Subject: Fuel Leak Case No. RO0000426 and GeoTracker Global BP #11109, 4280 Foothill Blvd,
Oakland, Geotracker Global ID T0600100217

Alameda County Department of Environmental Health (ACDEH) has reviewed the case file including the following reports prepared by Arcadis on Atlantic Richfield Company, a BP affiliated company (ARCO) for the referenced case:

At this juncture ACDEH requests that you address the Technical Comments below and submit a Data Gap Work Plan to advance the case to closure.

FORMER BP STATION #11109 4280 FOOTHILL BOULEVARD OAKLAND, CALIFORNIA	
GROUNDWATER ELEVATION CONTOUR MAP - MARCH 07, 2017	
ARCADIS <small>Design & Consultancy for natural and built assets</small>	FIGURE 2

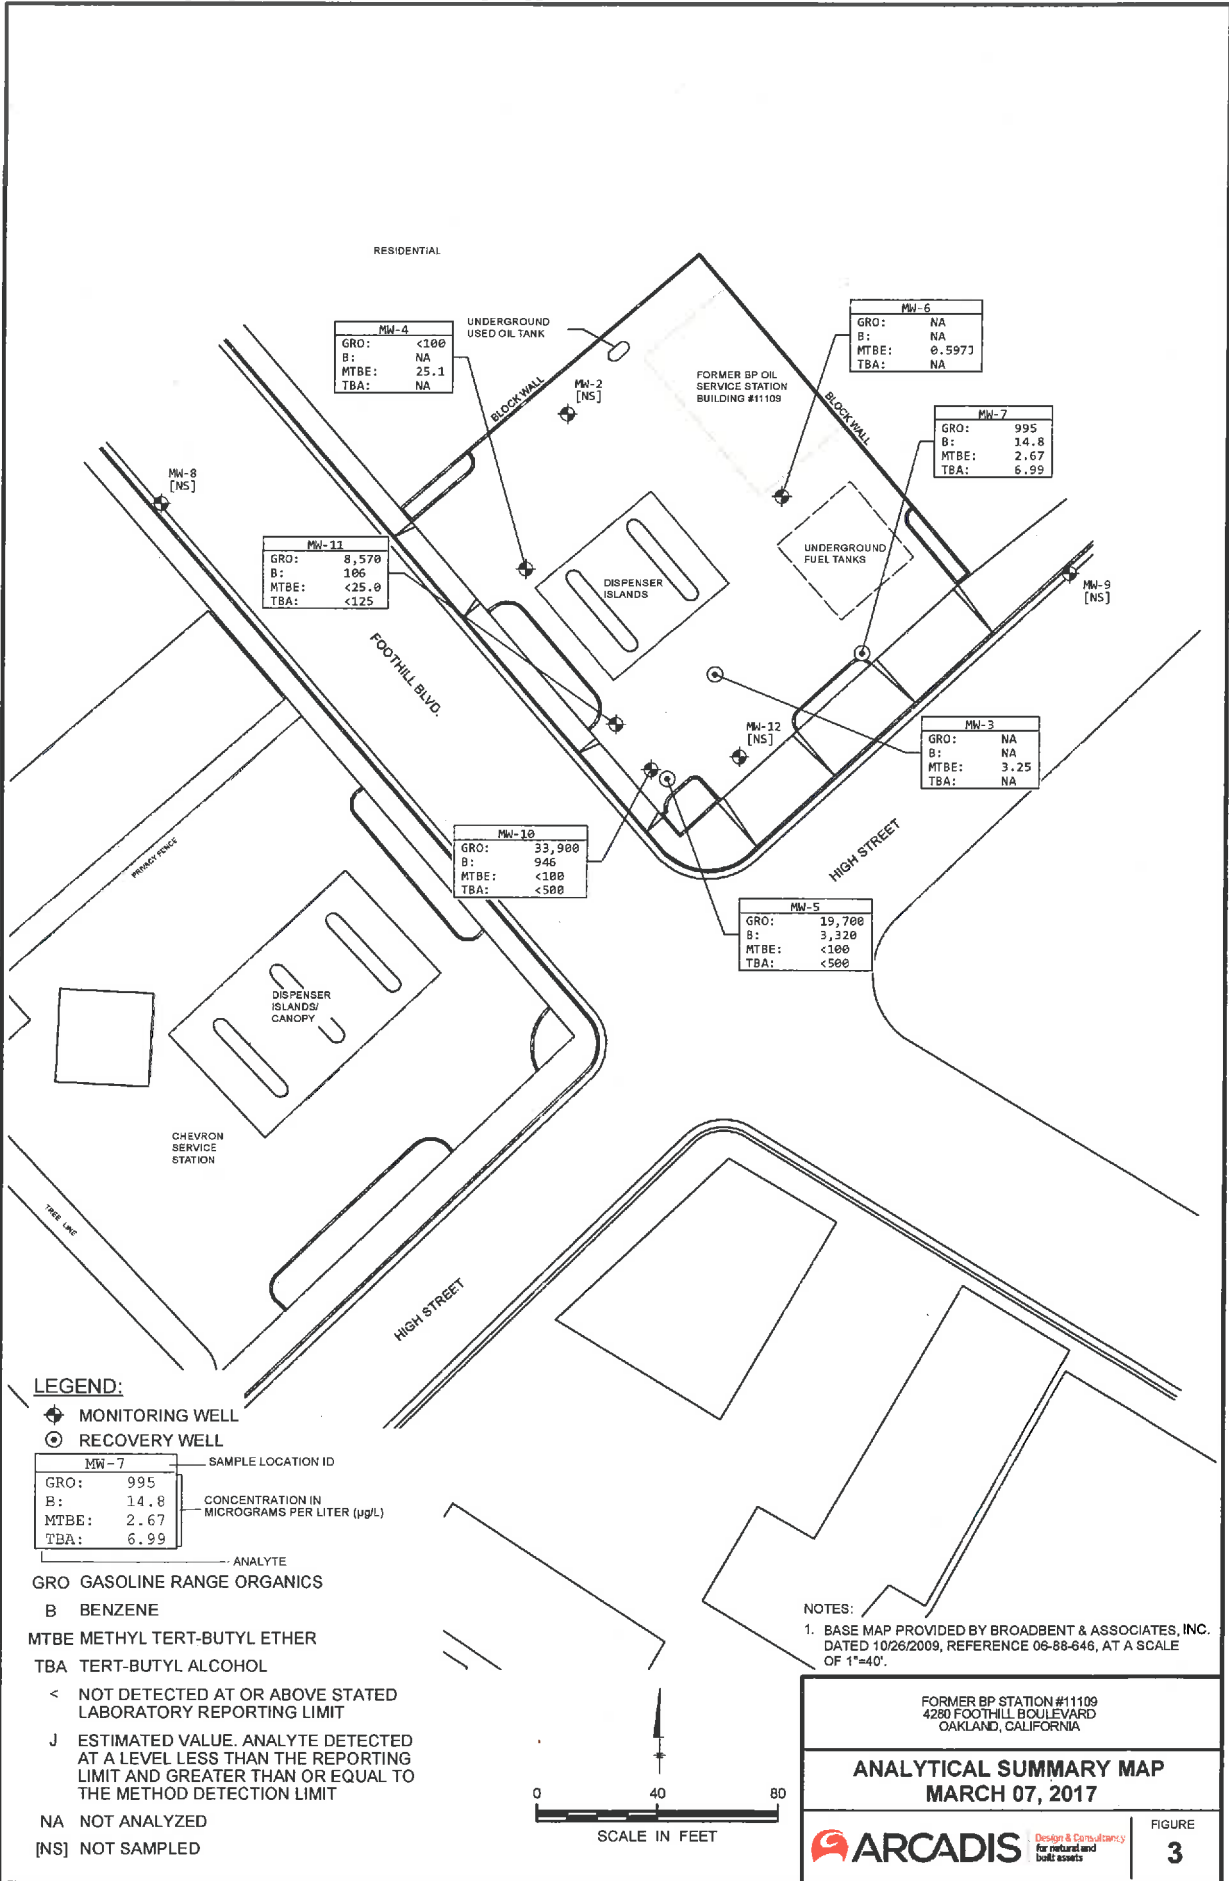
As described in the LTCP's *Technical Justification for Vapor Intrusion (VI) Media Specific Criteria*, light non-aqueous phase liquid (LNAPL) (free product) is indicated by benzene concentrations exceeding 3,000 micrograms per liter (ug/L) and total petroleum hydrocarbon as gasoline (TPHg) concentrations exceeding 20,000 ug/L. The 1st Quarter 2017 Report indicates that free product persists in groundwater monitoring wells MW-5, MW-10, MW-11, and MW-12 located in the southern corner of the site. A measurable thickness (0.02 feet or 0.24 inch) of free product was present in well MW-12 and benzene and TPHg concentrations exceeding the LTCP's *Technical Justification for Vapor Intrusion (VI) Media Specific Criteria* were detected in wells MW-5 and MW-10 (Attachment A, Tables and Figures March 7, 2017 Groundwater Sampling Event, BP Station, 4280 Foothill Boulevard and Chevron Station, 4265 Foothill Boulevard, Oakland).

Free product has been documented in well MW-5, installed in 1991, from 1991 to 2017. Free product or benzene and TPHg concentrations exceeding the LTCP's *Technical Justification for Vapor Intrusion (VI) Media Specific Criteria* has also persisted in MW-10, MW-11, and MW-12, installed in March 2009, from 2009 to 2017. The presence of free product continues despite completion of a Dual Phase Extraction Pilot (DPE) Test in 2013 and ongoing free product removal. Consequently, ACDEH requests submittal of a Corrective Action Plan Addendum as described below in the Technical Report Request Section.

ACDEH's review of the case files indicates that insufficient data and analysis has been presented to assess compliance with Media Specific Criteria for Groundwater. The groundwater flow direction appears to be to the southwest and has been defined by coordinated groundwater monitoring events between this case and at the neighboring Chevron Service Station, 4265 Foothill Boulevard (RO427). Historically, Chevron's upgradient groundwater monitoring well C-10, installed in 2003 and located 100 feet directly downgradient of MW-5, has not exhibited free product or benzene or TPHg concentrations suggestive of free product, and has not detected TPH in groundwater since 2003. The depth of underground utilities are unknown despite preferential pathway studies completed in 2013 and 2015. Due to the presence of numerous underground utilities beneath Foothill Boulevard as shown on figures in Attachment C, Underground Utilities, BP Station, 4280 Foothill Boulevard, and Underground Utilities Extended Site Figure, Former Shell Service Station, 4411 Foothill Boulevard (RO415), the utilities may act as preferential pathways potentially for free product concentrations. This represents a vapor intrusion vapor intrusion risk to the residential and commercial properties along Foothill Boulevard and High Street. Consequently, the length and direction of the contaminant plume that exceeds water quality objectives is unknown.

Corrective Action Plan Addendum – *A Final Feasibility Study and Corrective Action Plan (FS/CAP)* dated January 14, 2011 was approved by ACDEH in May 2011 but was not implemented. Please re-evaluate the FS/CAP and prepare a *Corrective Action Plan Addendum (CAP Addendum)* to address the technical comments listed above. Please support the scope of work with a focused Site Conceptual Model (SCM) and Data Quality Objectives (DQOs) that relate the data collection to each LTCP criteria. The CAP Addendum must include a concise background of soil and groundwater investigations performed in

SITE PLAN SHOWING BORING LOCATIONS

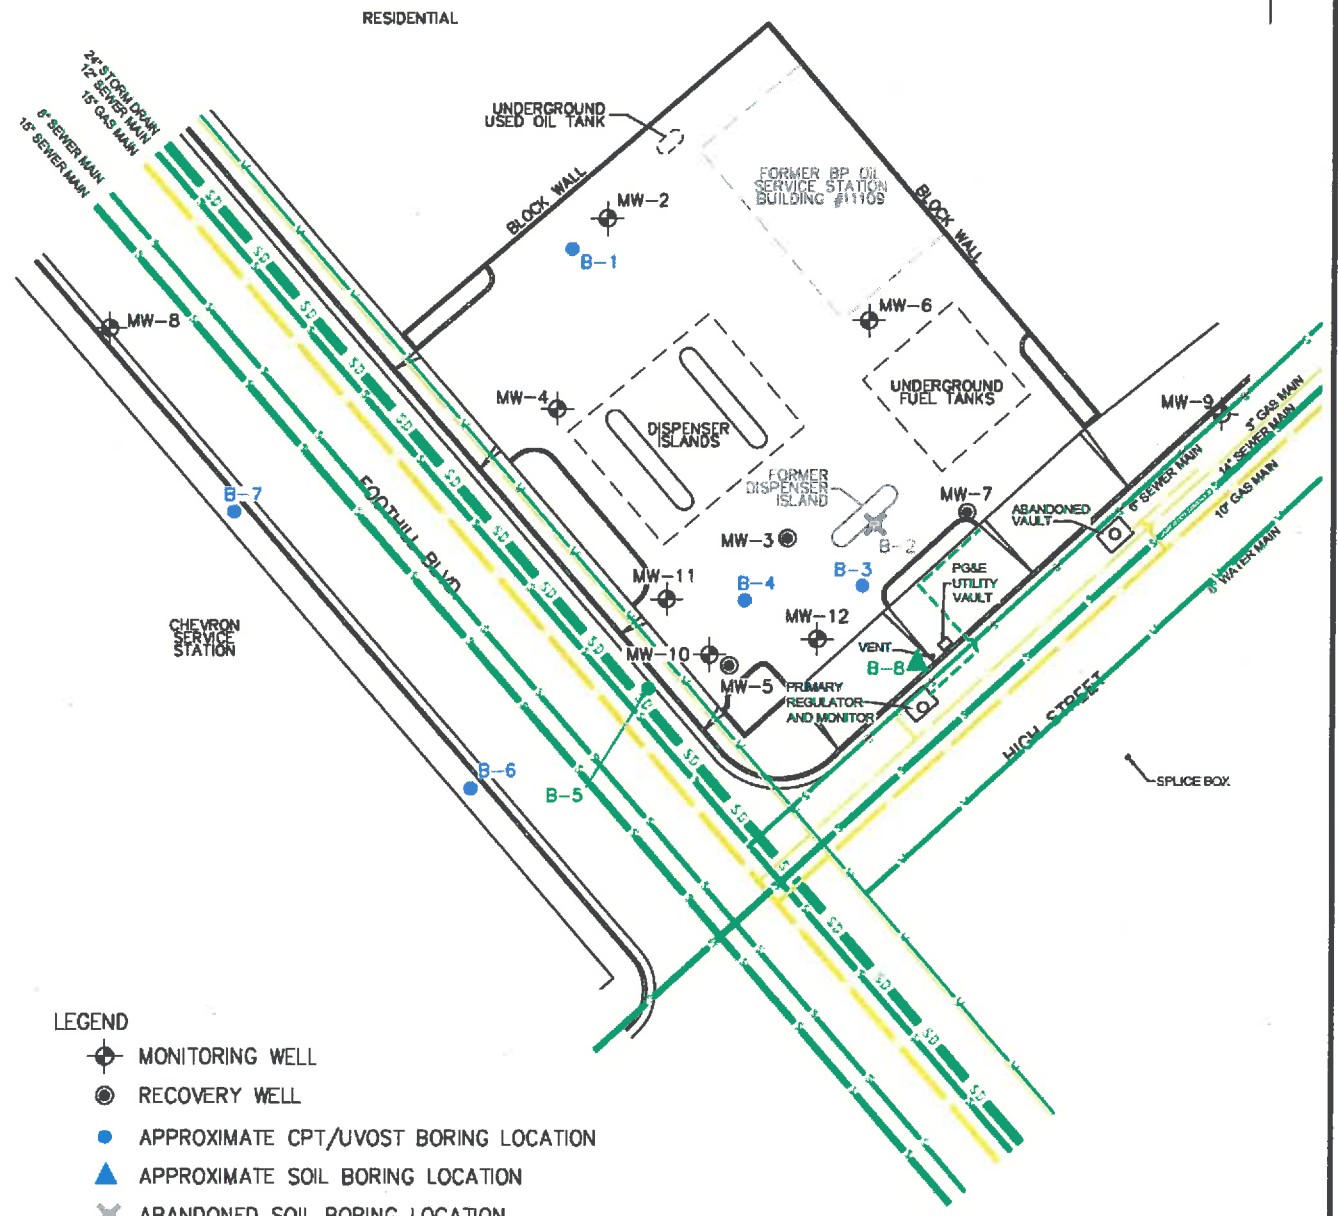
ACDEH's review of the case files indicates that insufficient data and analysis has been presented to assess compliance with General Criteria f. Historic data indicates the existence of at least two generations of USTs, associated piping and dispenser islands, and structures (c.1971 and c.1989). The continuous presence of free product in MW-5, MW-10, MW-11, and MW-12 indicates the existence of secondary or residual source. Additionally, examination of 1971 Mobil Oil Corporation site blueprints implies that High Street was widened in the early 1970's with High Street

encroaching over former station property potentially placing the pump islands closer to the current sidewalk at the corner of High and Foothill (Attachment B, 1971 Mobil Oil Corporation blue print). The widening of High Street may provide an explanation for the source of the unexplained free product at that corner. As you are aware, in March 2014 PG&E discovered shallow soil contamination during an excavation project in the High Street sidewalk/driveway on High Street near the corner at High Street and Foothill Boulevard. Consequently, ACDEH requests submittal of a Corrective Action Plan Addendum as described below in the Technical Report Request Section.
